## **BID Addendum #1**

**Project:** SFC-23N002; OSSB OSSD Energy Project  
**Date:** 5/1/2025  
**Location:** Ohio School for the Deaf  
**By:** Michael Chow, Metro CD Engineering

**A** LIGHTING PLAN, HEALTH SERVICES / ADMIN FIRST FLOOR ZONE A  
**E103** 1/8" = 1'-0"

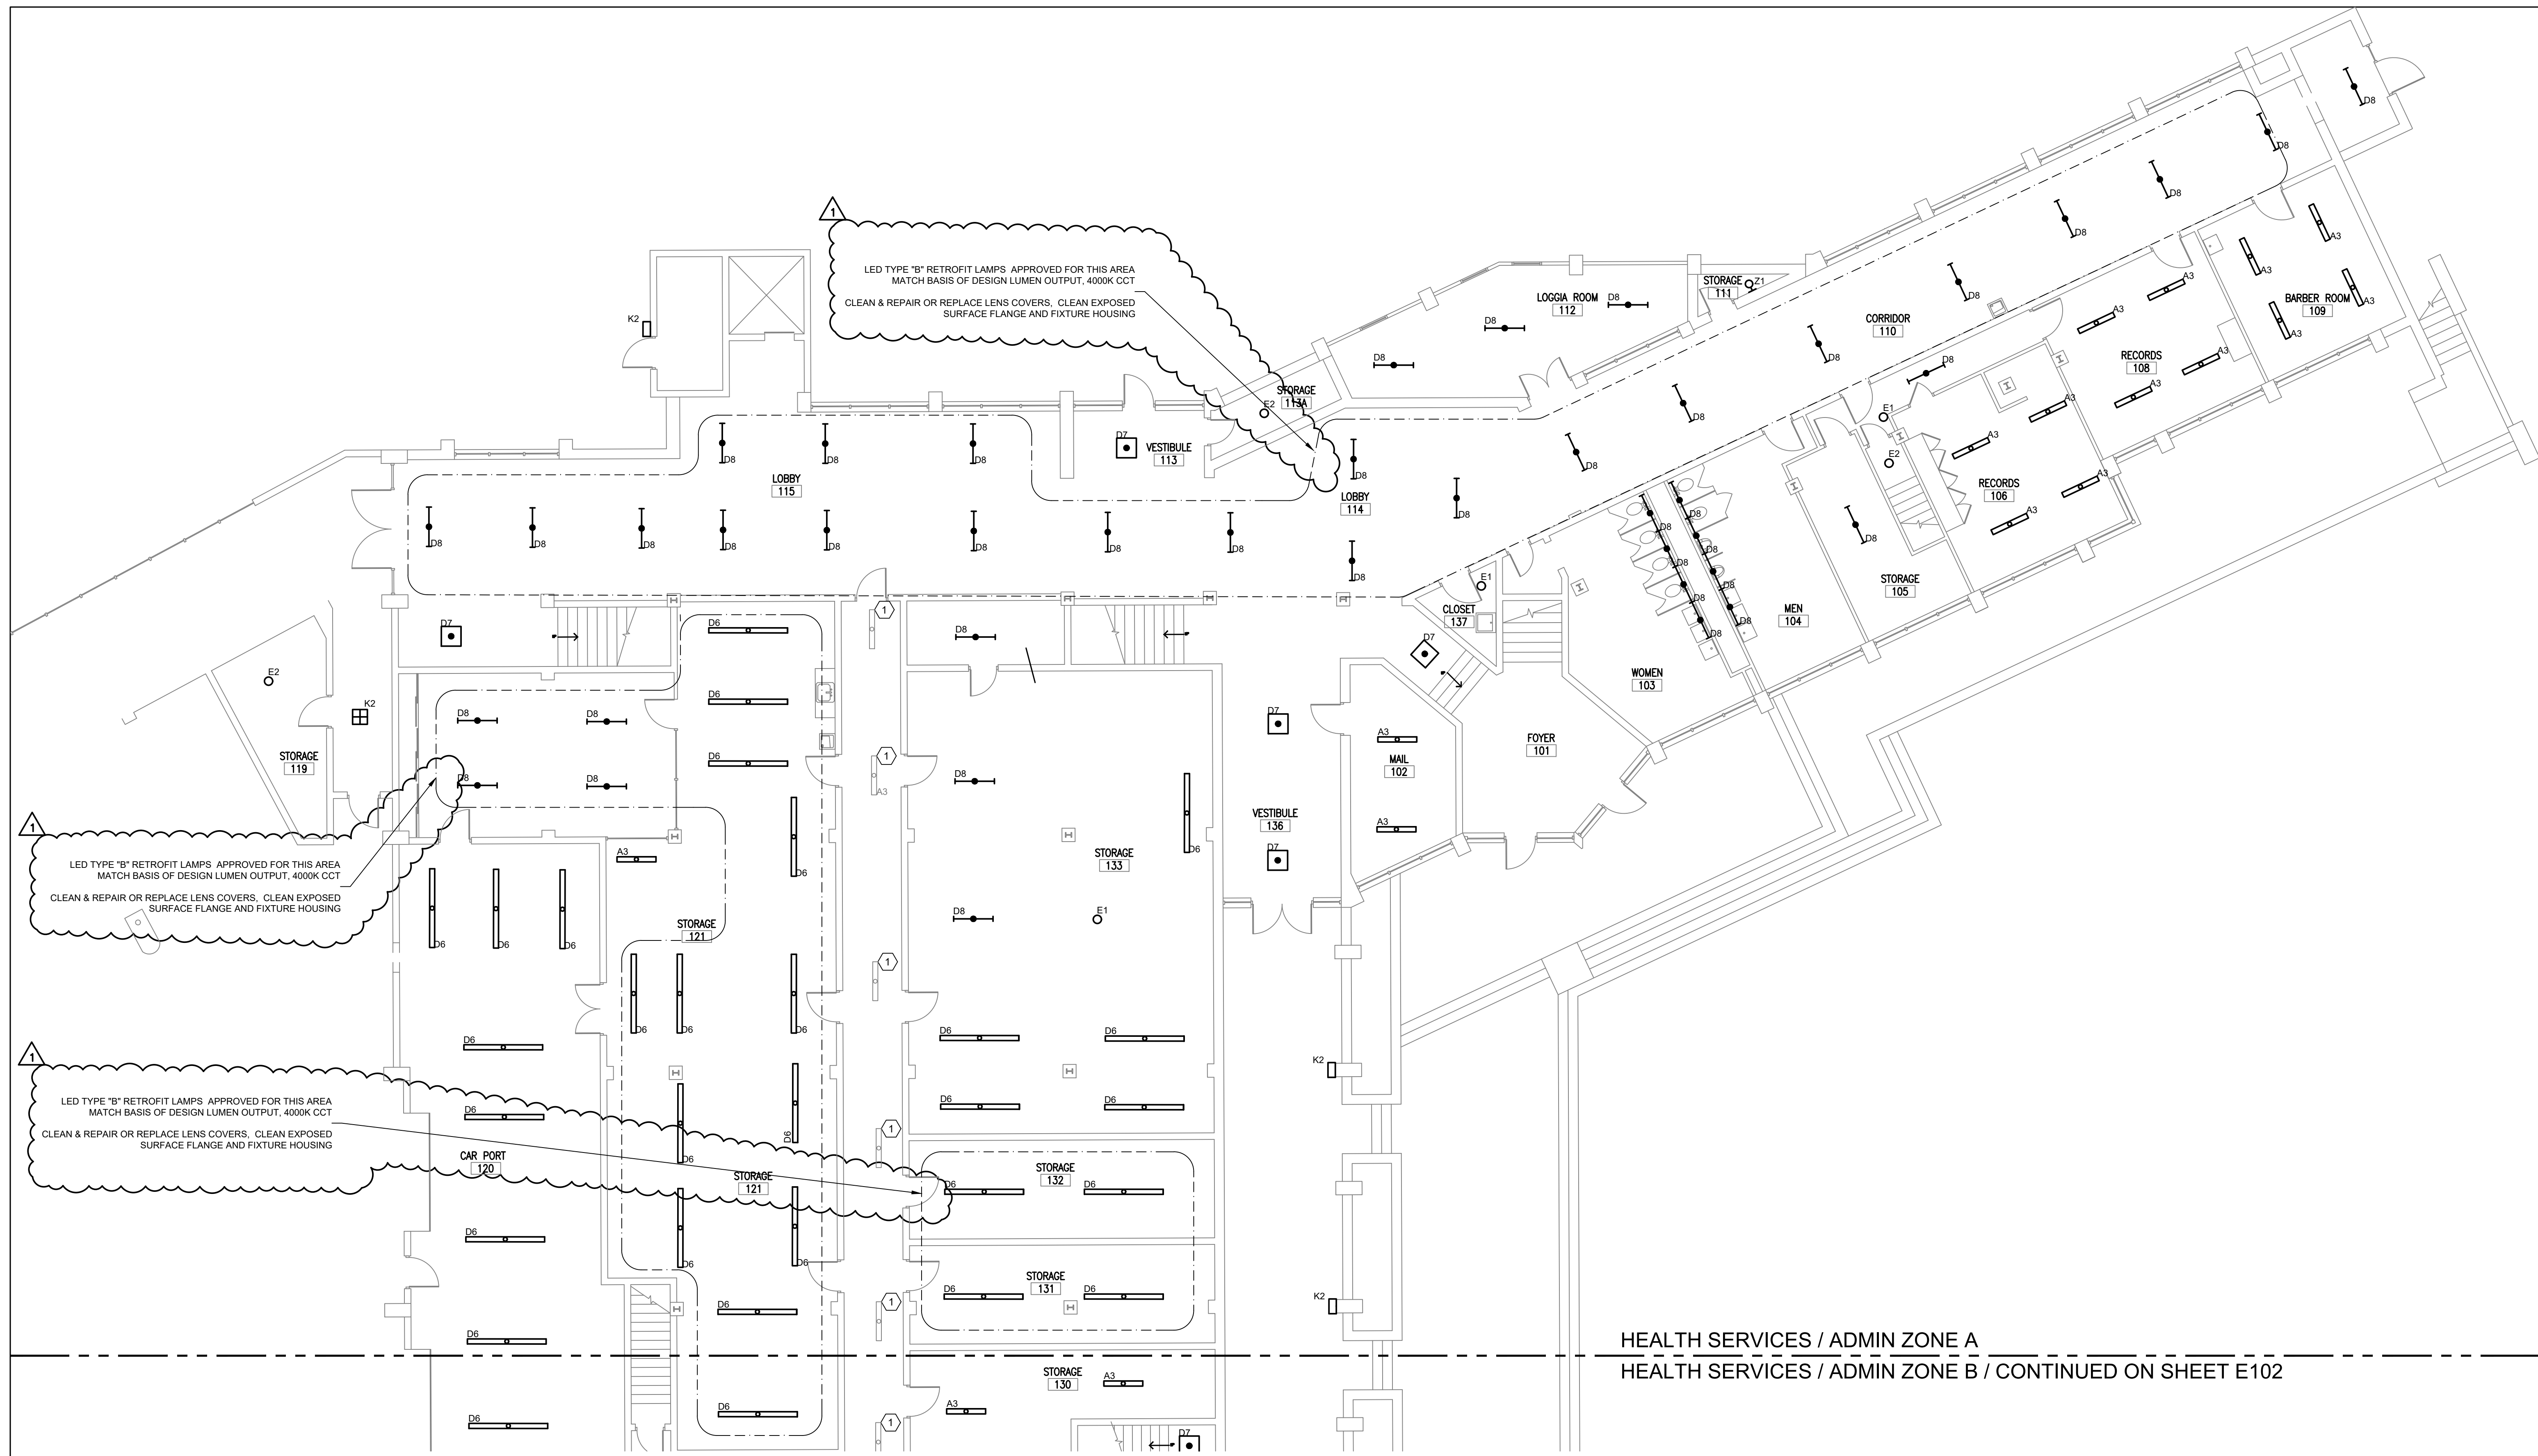
- d. OSSD Admin: Linear / utility strip / fixtures with end-to-end, through wired, and surface mounted 1x4 or 2x4 rectangular fixtures where mounting surface is of popcorn type finish are to be type "B" retrofit. Light fixtures approved for LED type "B" retrofit / re-lamp are as identified in drawings.

LED TYPE "B" RETROFIT LAMPS APPROVED FOR THIS AREA  
 MATCH BASIS OF DESIGN LUMEN OUTPUT, 4000K CCT  
 CLEAN & REPAIR OR REPLACE LENS COVERS, CLEAN EXPOSED  
 SURFACE FLANGE AND FIXTURE HOUSING

**A** LIGHTING PLAN, HEALTH SERVICES / ADMIN SECOND FLOOR ZONE A  
E104 1/8" = 1'-0"

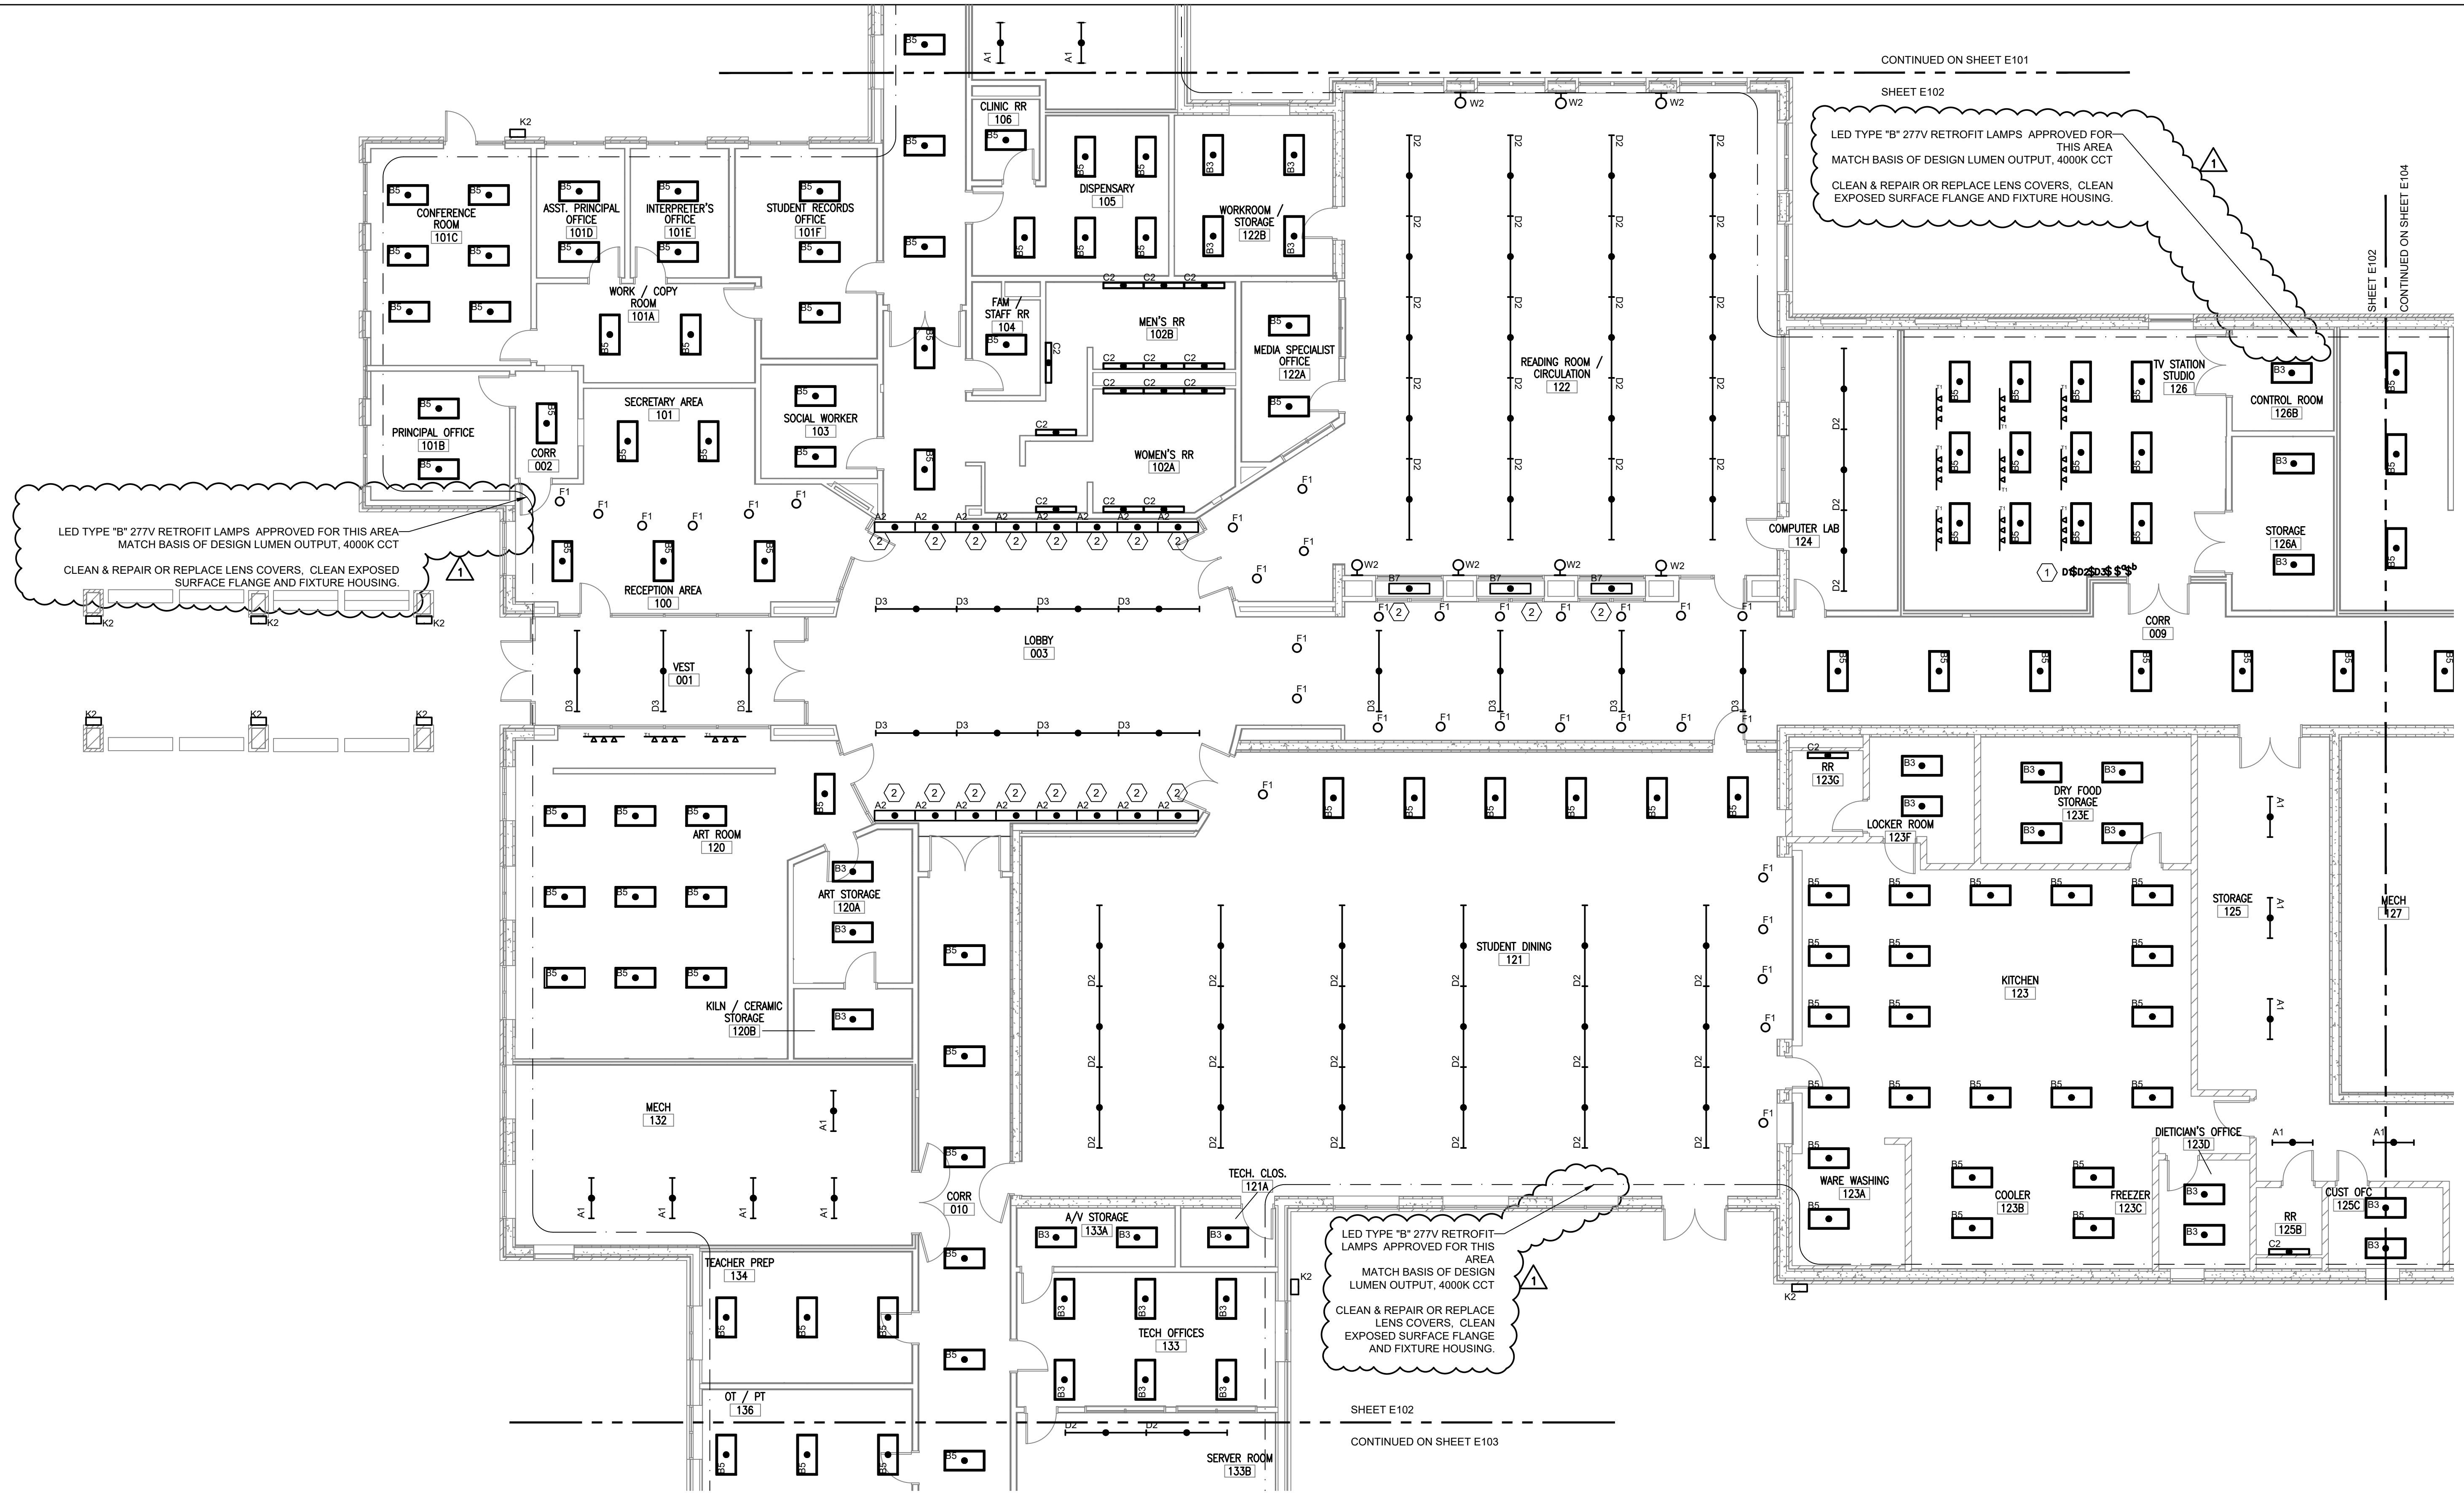
- e. OSSD Admin sheet E104, cafeteria area adjacent rooms added scope to relocate local lighting switching. Added clarification on cafeteria switching scope of work.

CODED NOTES	
3	DEMO EXISTING SWITCHING CONTROLLING RECESSED LIGHTING. PROVIDE (2) LINE VOLTAGE TOGGLE TYPE NON-DIMMING WALL SWITCHES. PROVIDE WIRING AND CONDUIT TO WIRE TRAVELERS TO H1 FIXTURES AS LABELED. DEMO EXISTING RECESSED PANELBOARD TUB PREVIOUSLY HOUSING SWITCHES. PROVIDE A COVER PLATE FOR ANY REMAINING WALL OPENING.
4	INTERCEPT EXISTING CIRCUIT IN THIS AREA, INSTALL NEW WALL SWITCH AND WIRING TO CONTROL THE EIGHT B5 FIXTURES LOCATED IN THIS AREA. FIXTURES CURRENTLY SWITCHED BY RECESSED PANELBOARD.
4A	EXISTING SWITCHING FOR ROOM LIGHTING IS PARTIALLY OPERATIONAL. INTERCEPT EXISTING CIRCUITS IN THIS AREA, INSTALL NEW DOUBLE GANGED WALL MOUNTED TOGGLE SWITCH. EXTEND / RELOCATE TRAVELERS FROM EXISTING SWITCH TO NEW SWITCH. EXTEND CIRCUIT COMMON TO NEW LIGHT SWITCH. LOCATE ANY OTHER SWITCHING TIED TO LIGHTING IN THIS AREA AND REPEAT RE-WIRING AS DESCRIBED ABOVE. DEMO EXISTING SWITCHES & PROVIDE WALL PLATE COVERS.

5	INTERCEPT EXISTING CIRCUIT IN THIS ROOM. INSTALL NEW WALL SWITCH AND WIRING TO CONTROL THE TWENTY FOUR D7 LIGHT FIXTURES INSTALLED IN THIS ROOM.

**A LIGHTING PLAN, GYMNASIUM**  
**E101 1/8" = 1'-0"**

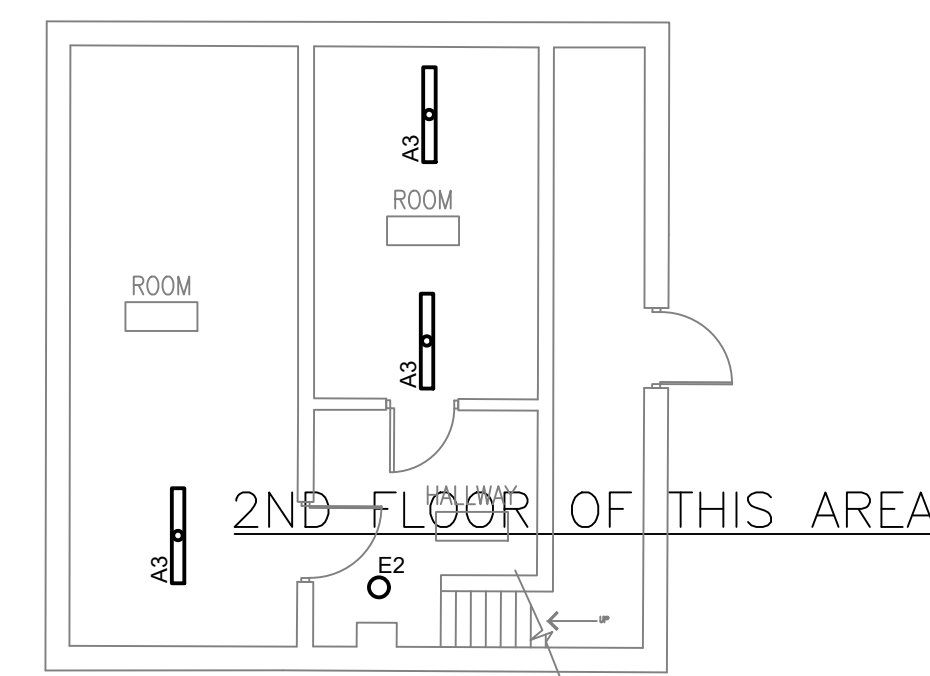
- f. OSSD New School: all interior fixtures to be type "B" retrofit (277V).
  - g. OSSD Old School gymnasium, sheet E101 switching to be demoed and re-wired using (4) 4-gang 3-way switches, bypassing existing lighting controller.

CODED NOTES	
1	BYPASS EXISTING LIGHTING CONTROLLER. DEMO (4) EXISTING LOW VOLTAGE GYM LIGHTING 6-PUSHBUTTON WALL MOUNTED CONTROLS HOUSED WITHIN SINGLE RECESSED SWITCH BOX. CONTRACTOR TO INTERCEPT (4) GYM LIGHTING BRANCH CIRCUITS BETWEEN LIGHTING POWER PANEL AND LIGHTING CONTROLLER. CONTRACTOR TO INTERCEPT GYM LIGHTING CIRCUITS BETWEEN LIGHTING CONTROLLER AND FIXTURES. CONTRACTOR TO INSTALL (4) NEW 4-GANG 3-WAY SWITCHES. COMPLETE WIRING & CONDUIT BETWEEN (4) NEW 4-GANG SWITCHES, (4) LIGHTING BRANCH CIRCUITS AND LIGHT FIXTURES.
2	SOUND PROOF ROOM, VERIFY EXISTING FIXTURE INSTALLATION DETAILS PRIOR TO WORK
3	FIXTURES ALREADY LED, REMOVE FROM SCOPE
4	NEW FIXTURE, NON LED, FIXTURE TO BE RELAMPED.
